## ADDENDUM NO. 2

DATE: February 10, 2025

PROJECT: ORCHARD VALLEY GOLF COURSE BRIDGE REPLACEMENTS

FROM: Engineering Enterprises, Inc.  
52 Wheeler Road  
Sugar Grove, Illinois 60554

EXPIRES: 11-30-2026  
SIGNED: 02-10-2025

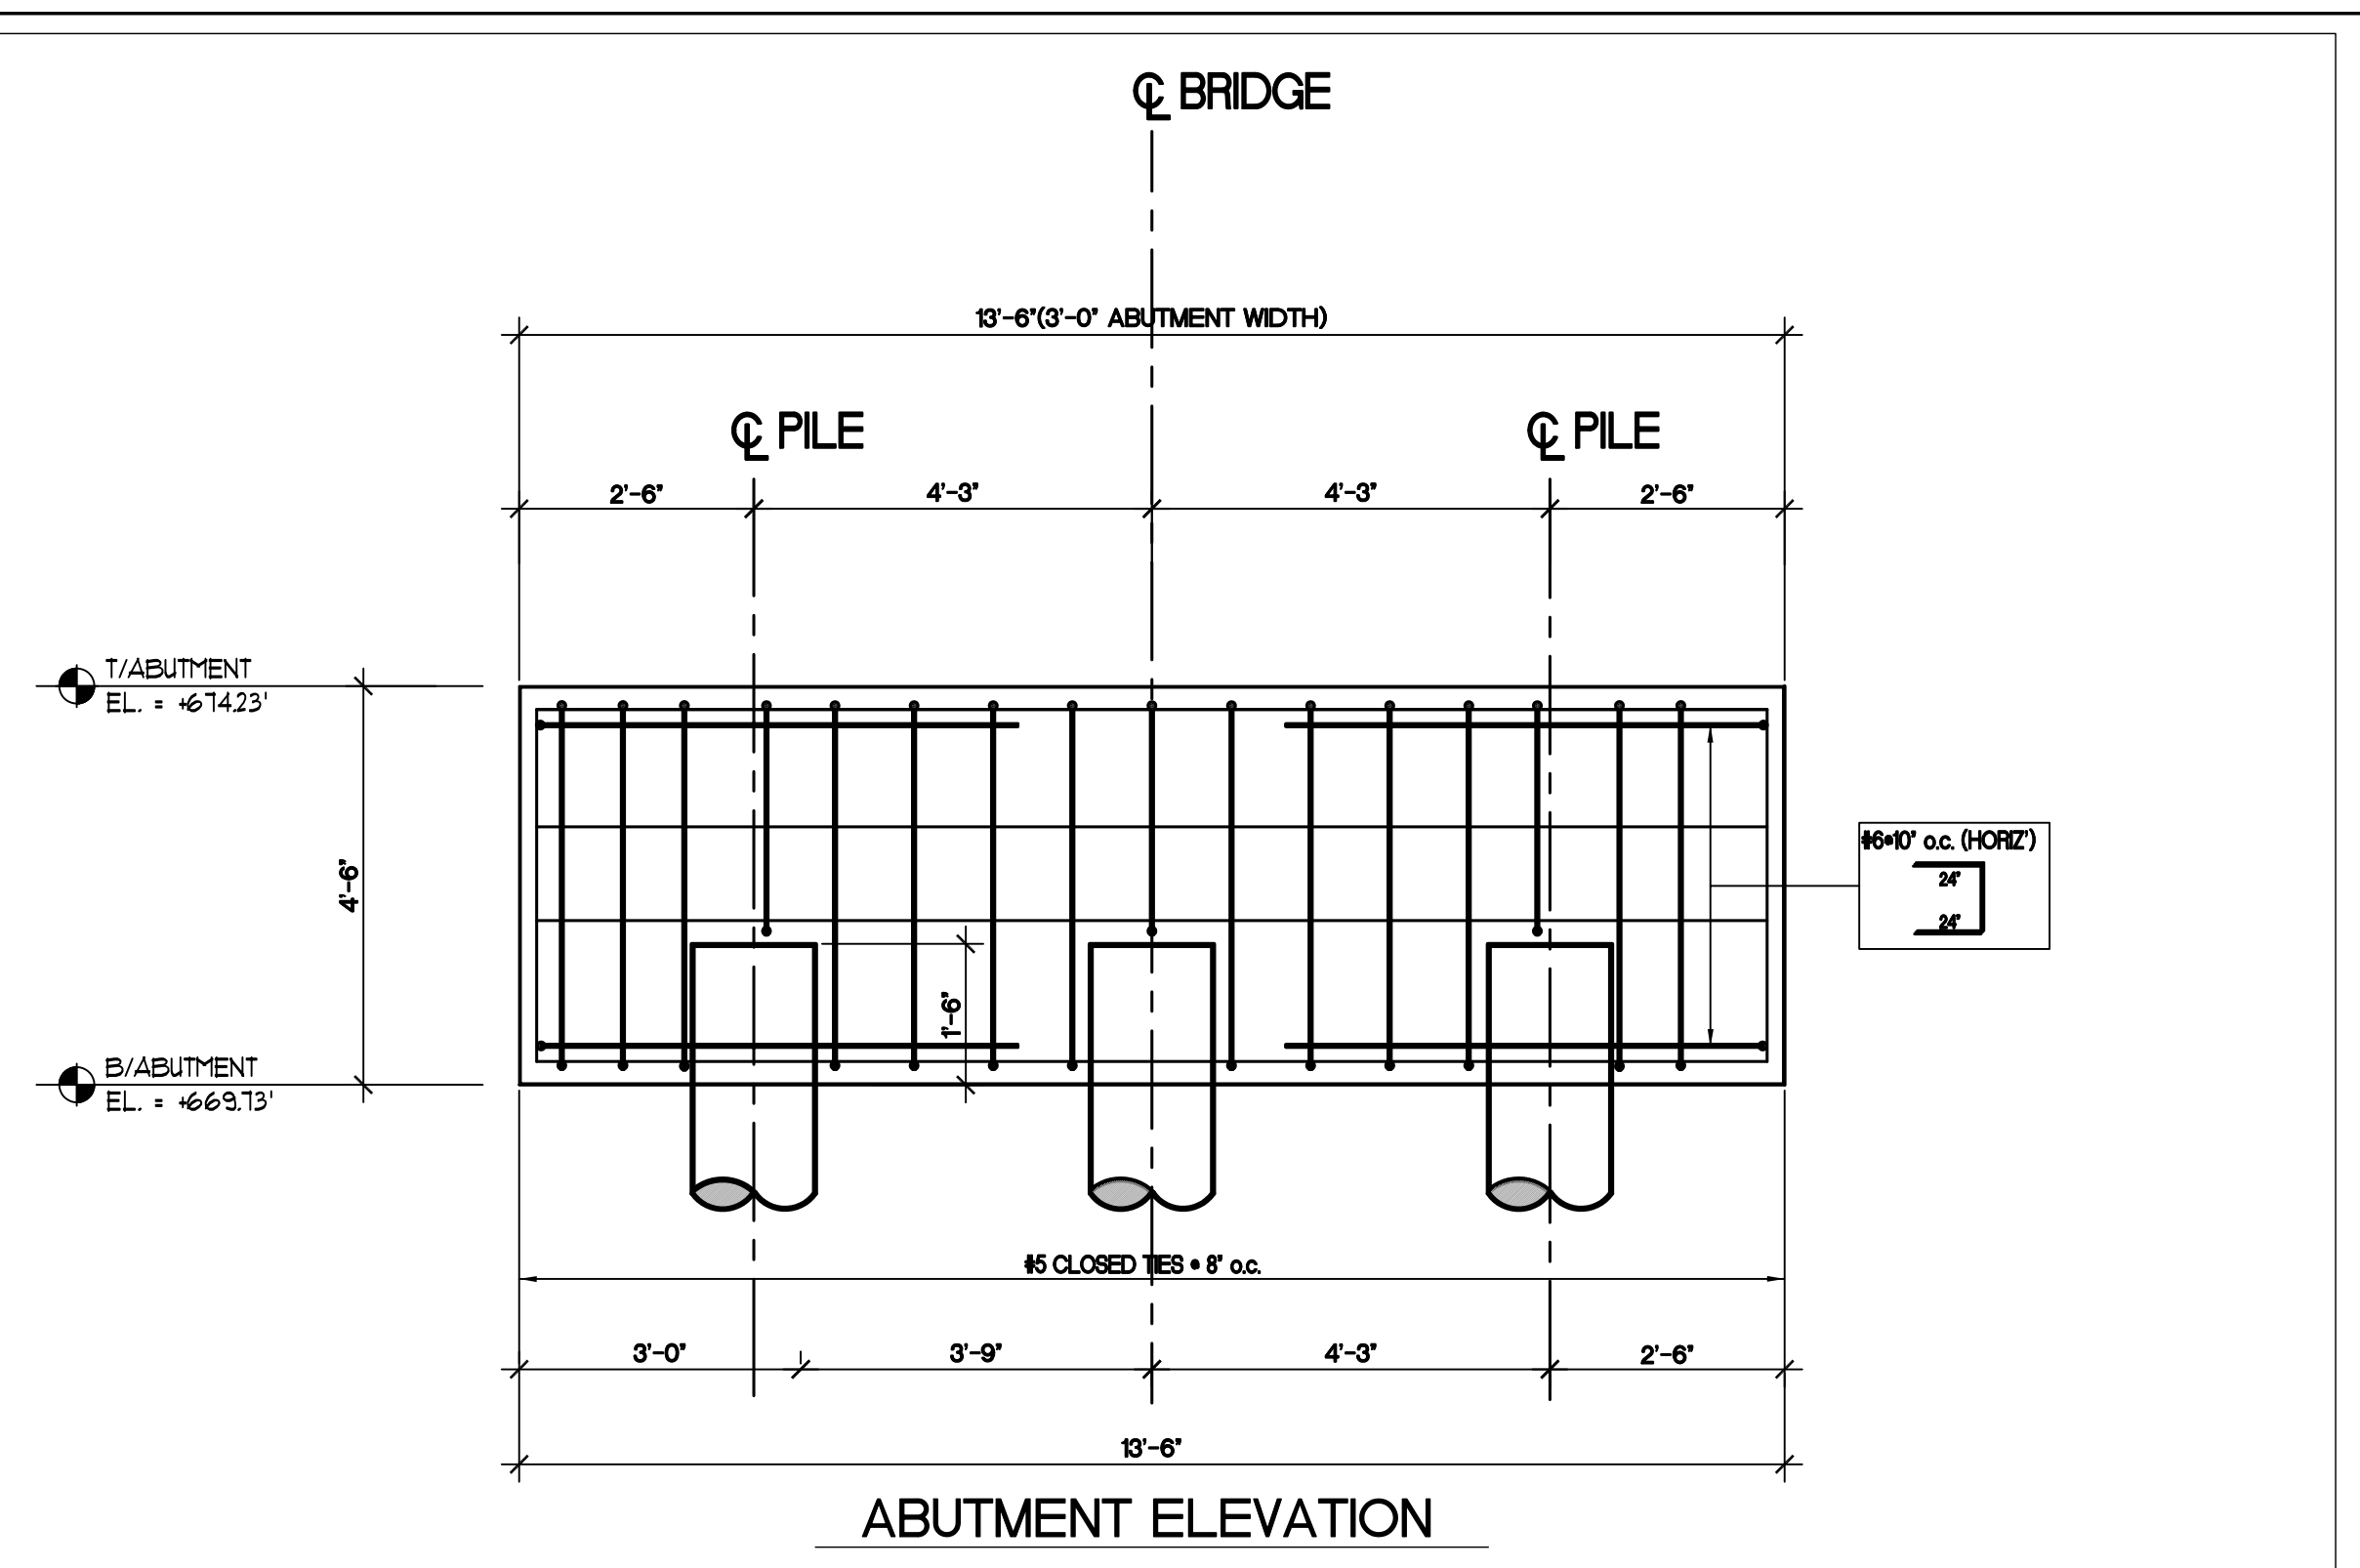
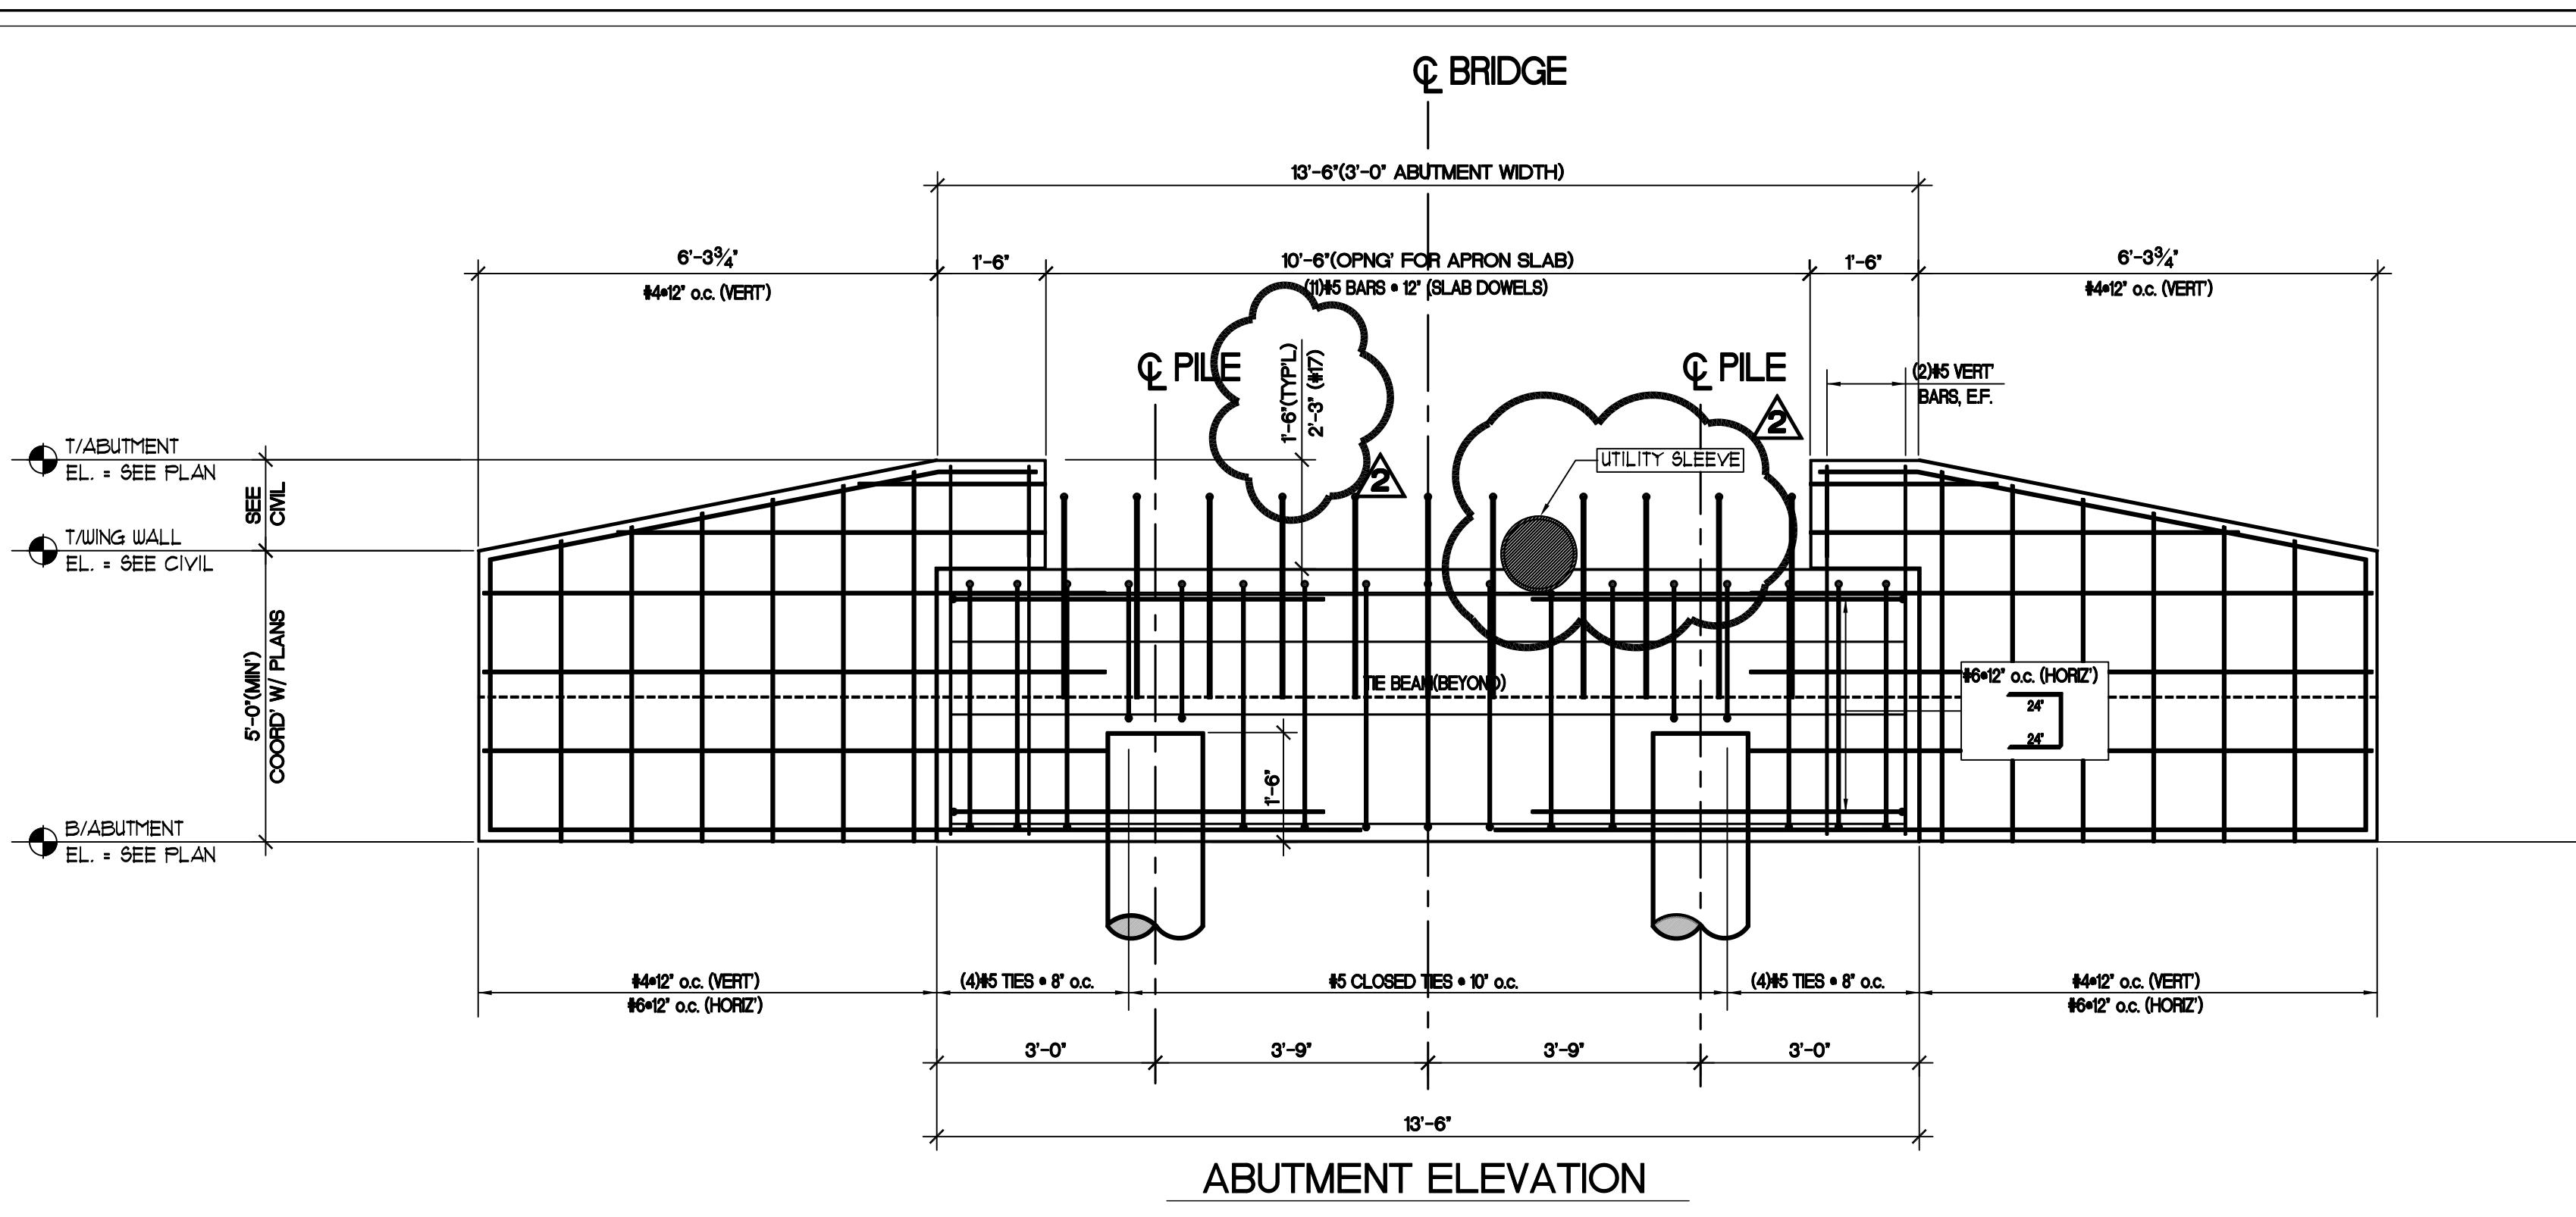
7. **Question 7:** *Can Item 21 TEST PILE METAL SHELL and Item 22 Driving Piles be performed to IDOT Standard Specifications, Design Manual, procedures and methods as opposed to what is detailed on Page S2 of 13 in the Hollow Shell Piling Notes. Methods detailed on Page S2 of 13 in the Hollow Shell Piling Notes are not local industry standard practice and lacks clarity, the Contractors that will provide pricing for this project typically drive piling according to IDOT Standards, Design Manual, and procedures with the Owners Rep/Engineer typically providing determination of bearing, pile record keeping and furnished lengths. The cost of the Independent Testing Laboratory, directed by a Professional Engineer (Hollow Shell Piling Note 8) and the Compression Load Test according to ASTM D 1143 (Hollow Shell Piling Note 9) will add several hundred thousand dollars to the contract time that can be avoided by following IDOT Standards, Design Manual, and methods.*

8. **Question 8:** What concrete mix shall be used to fill the shell piles. IDOT typically use a drilled shaft mix.

**Response to Question 7:** Following IDOT Standards is acceptable. In lieu of using a test pile, driving piles to refusal is an acceptable alternate.

**Response to Question 8:** IDOT class DS mix shall be used. (4,000 psi) Please refer to sheet S2 for mix design information.
